**RESPONSE OF CITIZENS FOR RESPONSIBLE DEVELOPMENT TO
VALOR DEVELOPMENT’S REVISED VOLUNTARY DESIGN REVIEW
APPLICATION**

Zoning Commission Case No. 16-23

This statement in opposition is filed by Citizens for Responsible Development (“CRD”) in response to revised plans (the “Revised Application”) for redevelopment of the SuperFresh site (“SuperFresh site”) filed by Valor Development (the “Applicant”) on October 16, 2018. CRD is a party in this case. The case dates from the Applicant’s filing of a Design Review Application on October 26, 2016. The Zoning Commission’s record for this case is extensive. Following two evenings of public hearings and submission of post-hearing briefs by the Applicant and CRD, the Applicant on three occasions asked for deferral of Zoning Commission deliberation.

Figure 1: Designated TDR Receiving Zones. Source: DCGIS

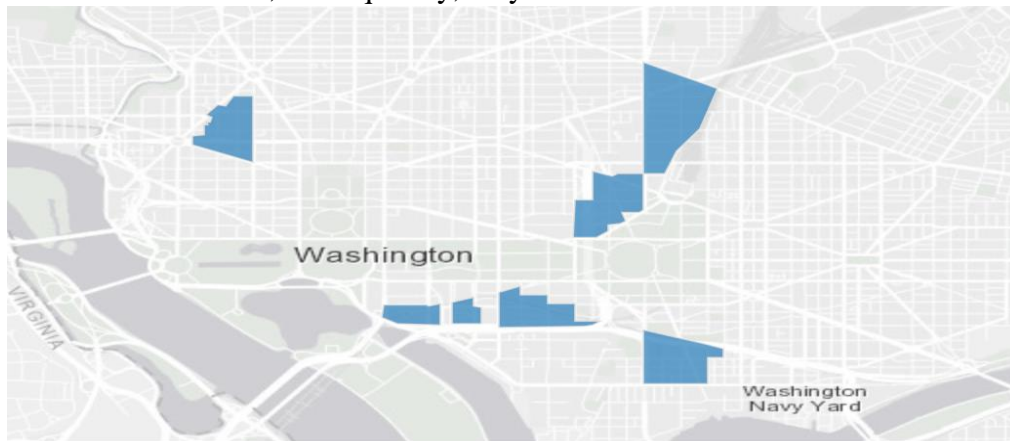
- A. **No Transfer of Density Can Be Received by the Project:** As discussed above, the voluntary Design Review Regulations do not allow the Applicant to utilize GFA from the SVSC, as that will constitute an impermissible increase in density. Moreover, credit trade areas (formerly TDR or CLD zones under the 1958 Zoning Regulations) only exist under the 2016 Zoning Regulations in five downtown Receiving Zones: South Capitol, Downtown East, North Capitol, Southwest, and New Downtown. See Figure 1 below. Lots 806 and 807 are not located anywhere near any of these five Receiving Zones and have never been eligible for TDR or CLD credits; consequently, they cannot be utilized here.
